**Original KOSTYRKA® Clamping Discs  
have an improved design!**

The well-established design of our KOSTYRKA® Clamping Discs has been developed.

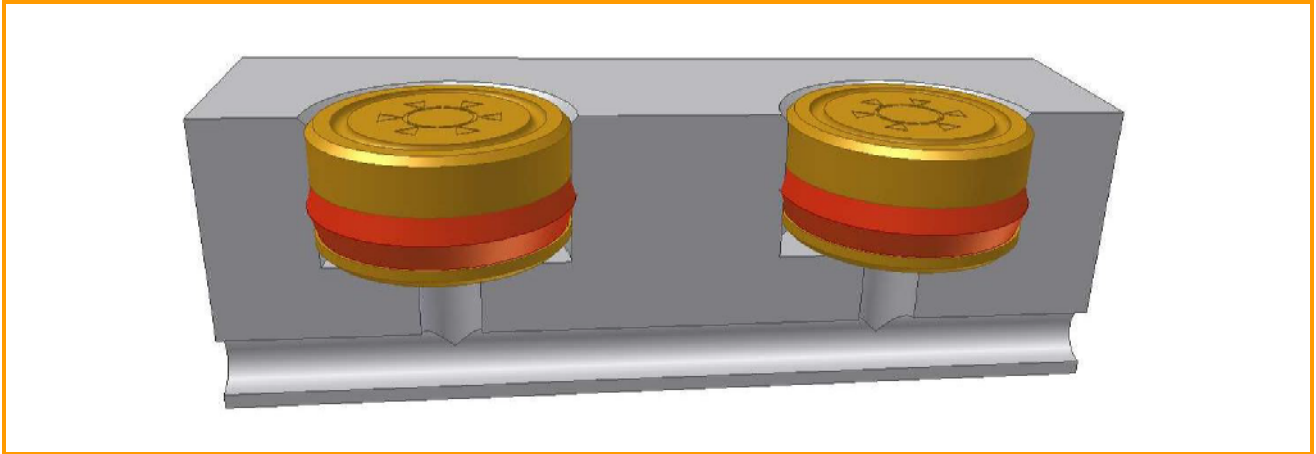
Therefore you get the Clamping Discs from now on in an advanced design:

- considerably **increased working pressure** - now up to 450 bar, for a short time up to 600 bar
- a **nearly doubled clamping force**
- substantially **increased lifetime** due to an improved sealing concept
- considerably simplified installation due to the **cancellation of the installation tool**
